# Service Bulletin

#FRSB0028

**Date of Bulletin:** January 20, 2010  
**Effective Date:** January 23, 2010  
**Pump Series Affected:** 1200 & 4200 Series  
**Affected Components:** Bypass Valve Cap  
**Subject:** Possible Leaks at Bypass Valve Cap  
**Issuing Authority:** Engineering

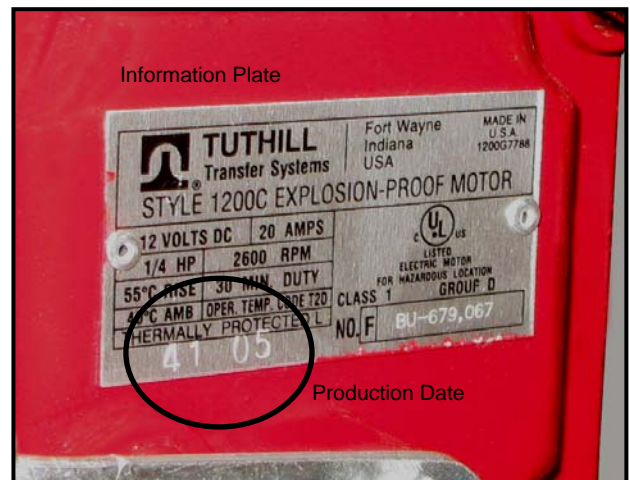
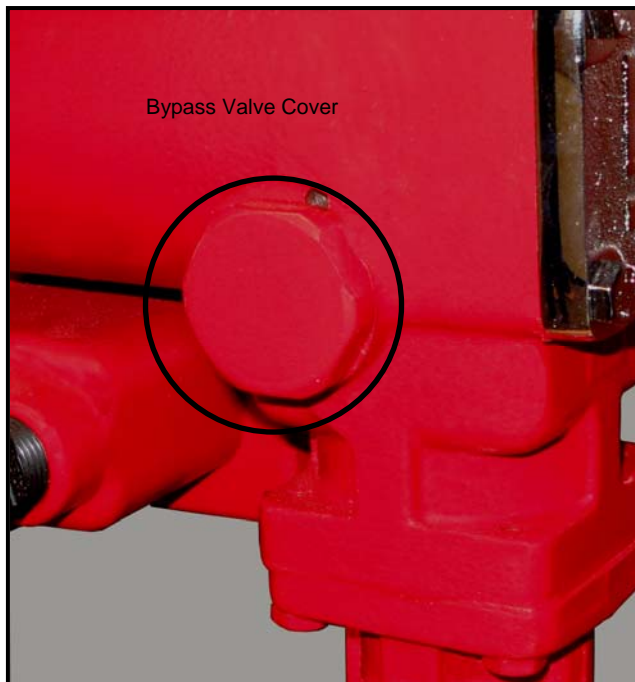
The Fill-Rite Division of Tuthill Transfer Systems is releasing FRSB0028 to address the potential for a fluid leak at the bypass valve cover on certain 1200 Series and 4200 Series Transfer Pumps. Affected models were manufactured between January 1, 2010 and January 19, 2010. If not seated and sealed properly, depending on the fluid being pumped, the potential for fire exists if a leak occurs at the bypass valve cover in the presence of an ignition source.

To determine if your pump may be affected, locate the information plate affixed to the right end of the motor (just behind the power switch). The production date of the pump is stamped on this plate. This TSB is applicable to pumps with the following dates:

If your pump falls in this production range, inspect the bypass valve cover (on the back of the pump housing) for signs of leakage. If there is fluid leakage around the cover, torque the cover (up to 100 ft lbs.) to stop the leak. **DO NOT EXCEED 100 ft lbs. of torque.** If leakage persists after torque has been applied to the cover, return the pump to the place of purchase for factory repairs.
